City of Los Angeles

REPORT ON APPEAL FROM DETERMINATION OF SUPERINTENDENT OF BUILDING  
REFERRED TO THE BBSC WITHOUT RECOMMENDATION FROM THE COMMISSION STAFF

BOARD FILE: 210036  
C.D.: 5 (Councilmember Paul Koretz)  
PLANNING AREA: West Los Angeles  
ZONE: [Q]RD1.5-1  
BUREAU/DIV.: Inspection/Grading  
DISTRICT OFFICE: West Los Angeles  
PRIOR BOARD ACTION: No  
ORDER: No

JOB ADDRESS: 1751 1-12 – 1759 SOUTH MALCOLM AVENUE &  
1772 – 1774 1-6 SOUTH GLENDON AVENUE

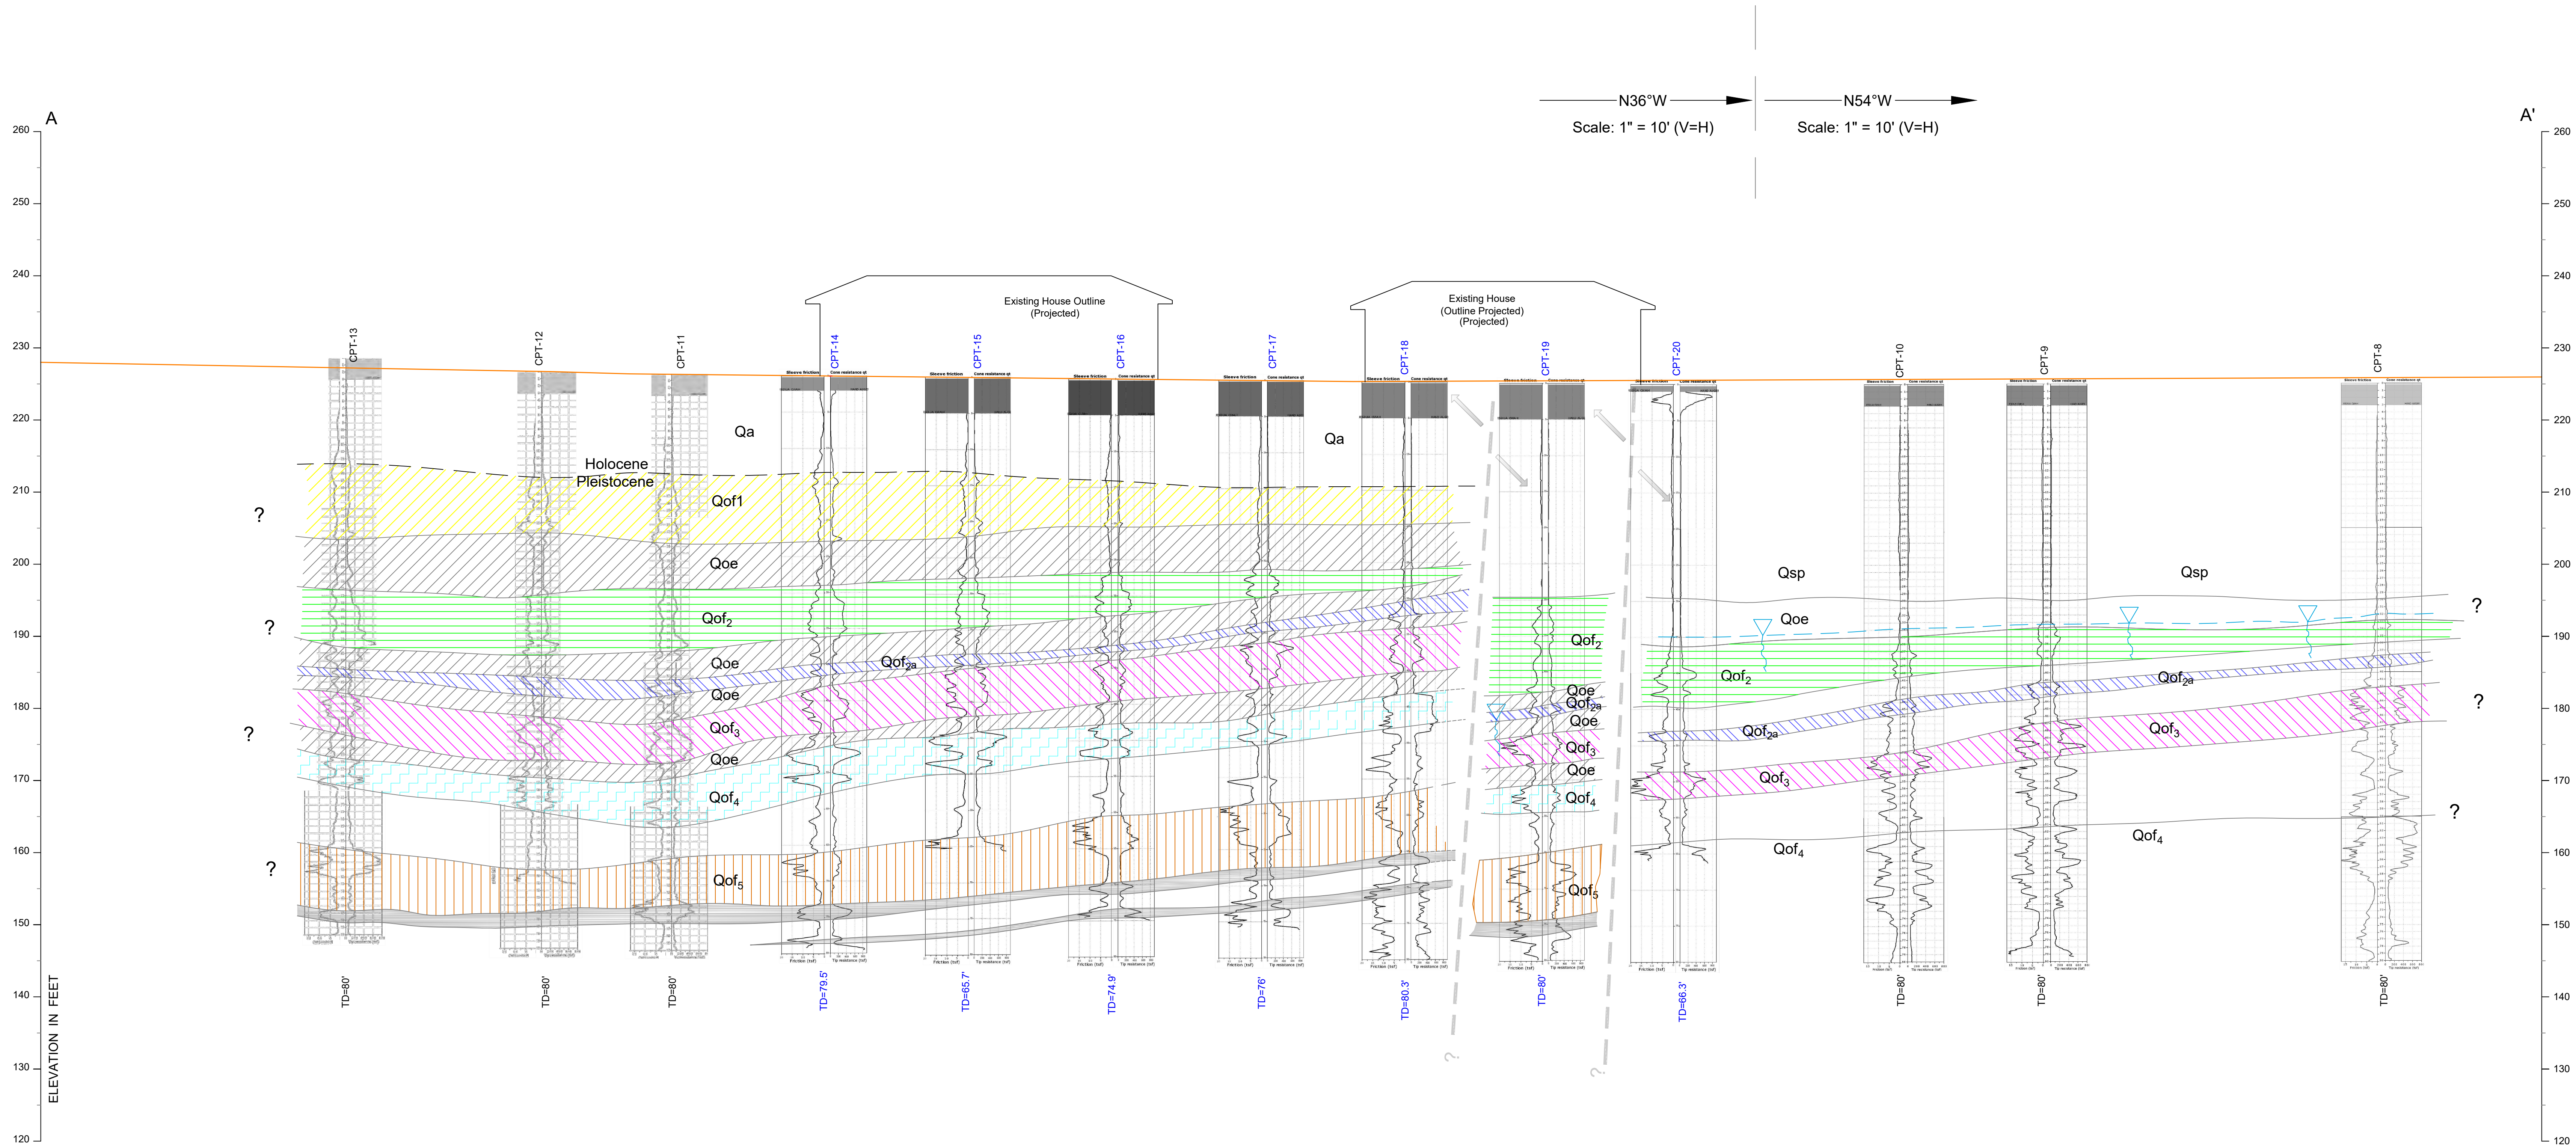
mischaracterization of the fault lying in the northeastern area of the site is contradicted by Figure 16 in CGS FER 259, p. 27. The December 29, 2015 denial summary from LADBS (Exhibit C) incorrectly claims the fault was in the **northeastern** portion of the site, when the fault rupture study on page 27 of FER 259 shows it running through the center of the site between *CPT 18* and *CPT 19* as shown below.

FER 259 is binding upon the City. It cannot under state law, impose weaker conditions. **The no-build area is required, and it is in the center of the site, not the northeastern edge, based on Figure 16 in FER 259.** Based on his sending the 2016 studies to CGS, and his two previous denials, Mr. Schneidereit was clearly aware of the role of CGS in regulating surface rupture fault investigations and of the recommendation for a no-build area.

**FIGURE 2 – Summary of 1749/1751 Malcolm Avenue and 1772 Glendon Avenue Fault Information Based on AES Reports and Related Data**

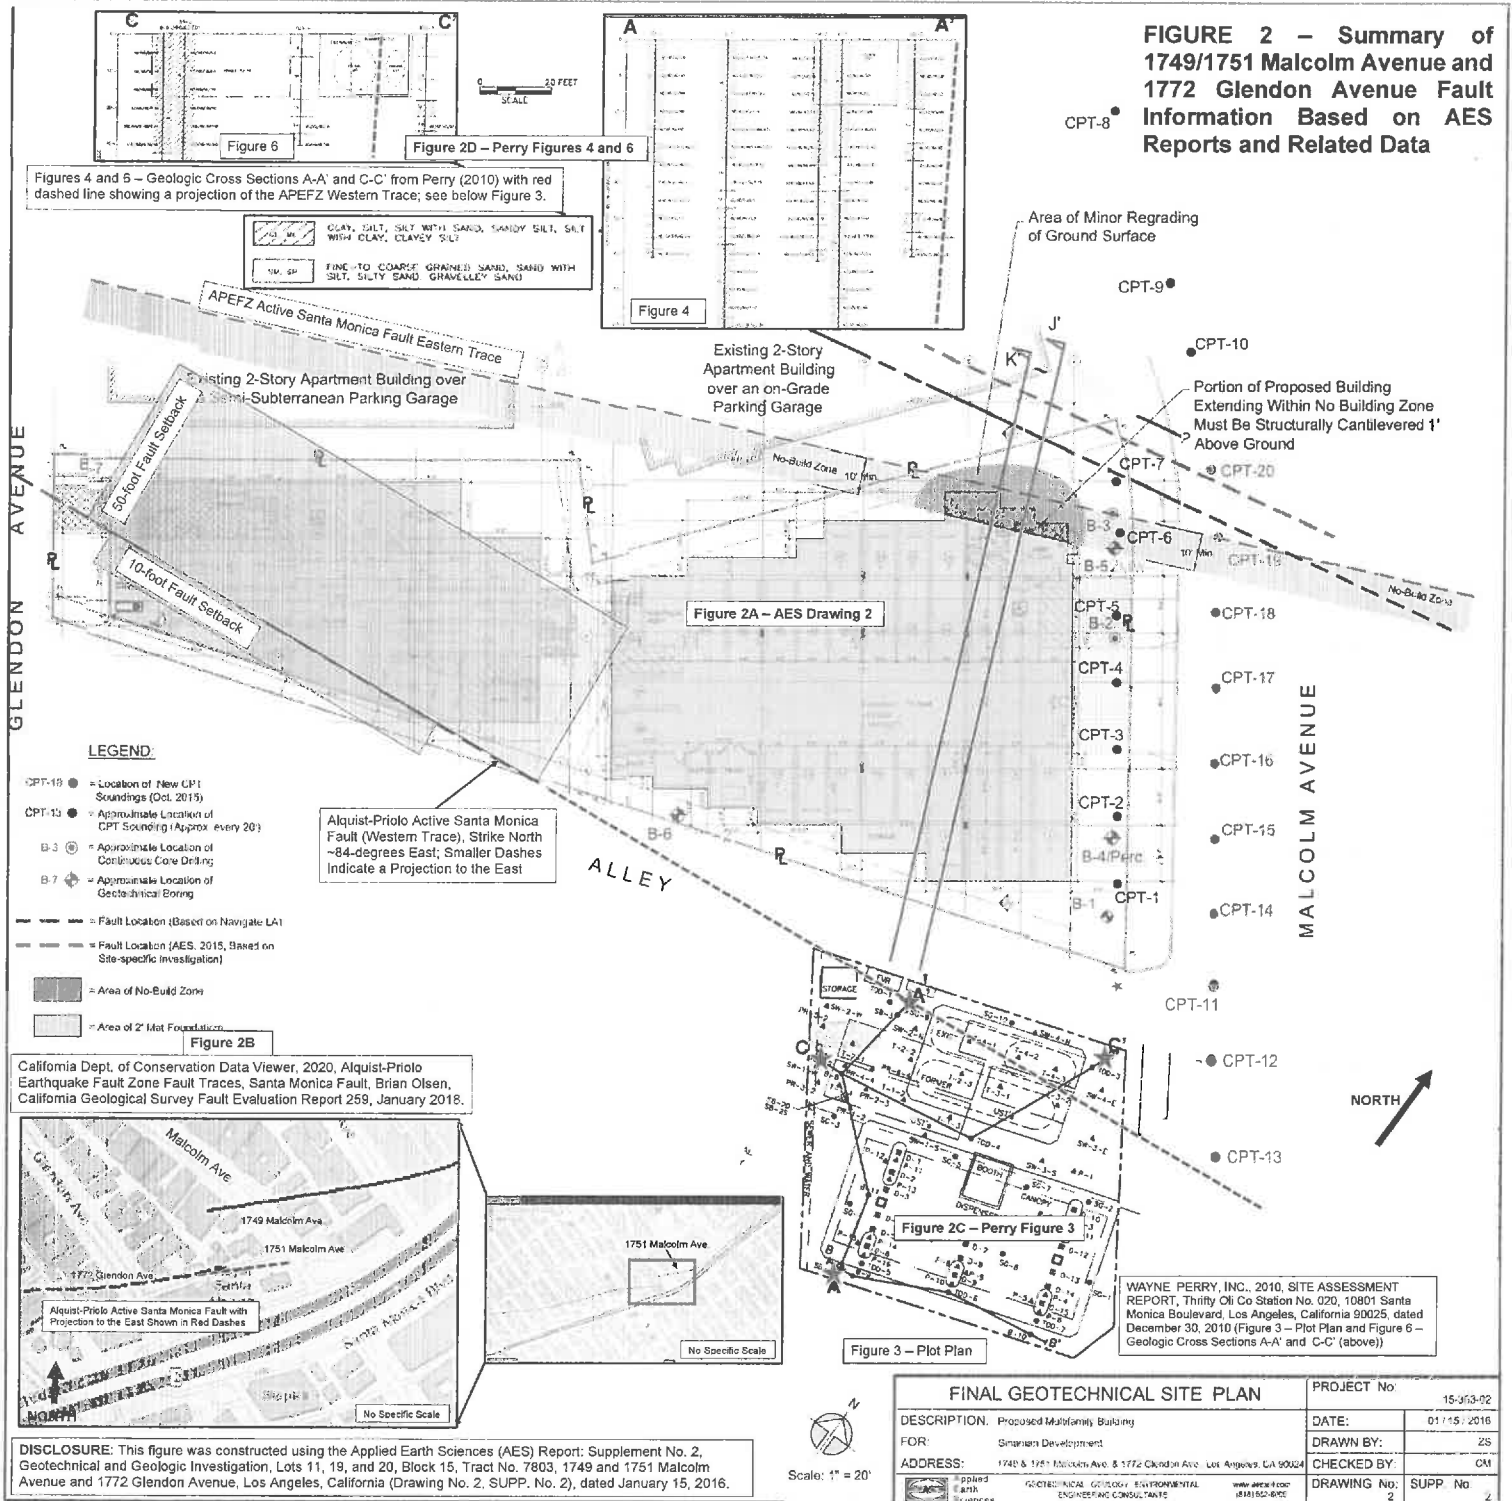
Eastern Fault Trace - FER-259 shows two APEFZ fault traces at the Site, each crossing portions of the proposed development area (Figure 2B). AES focused their studies only on the eastern fault trace entering the Malcolm Project s from the east and crossing a portion of the northcentral section of the Site. The AES reports

Western Fault Trace - FER-259 shows an APEFZ fault trace (Figure 2B) entering the Glendon Project site about midway along the western Site boundary and trending approximately north 84-degrees west. This fault crosses the proposed Glendon Project site development then exits the south side of the Glendon Project site at roughly the boundary driveway between 1751 Malcolm and 1772 Glendon at the alley. Had AES performed analysis of historic aerial photographs and topographic maps as was done for FER-259 and mandated by City of Los Angeles P/BC 2014-129 and 2020-129, they would likely have found this western fault trace entering the Site from the west and crossing a portion of the central section of the Glendon Project Site. No investigation was conducted along Glendon Avenue, along the driveway between the two lots, in the open space between the houses on the lot, or along the adjacent alley on the south similar to the investigation along Malcolm Avenue. Therefore, this western APEFZ trace was not determined to be present or absent as required within a known APEFZ before the final permit was approved.
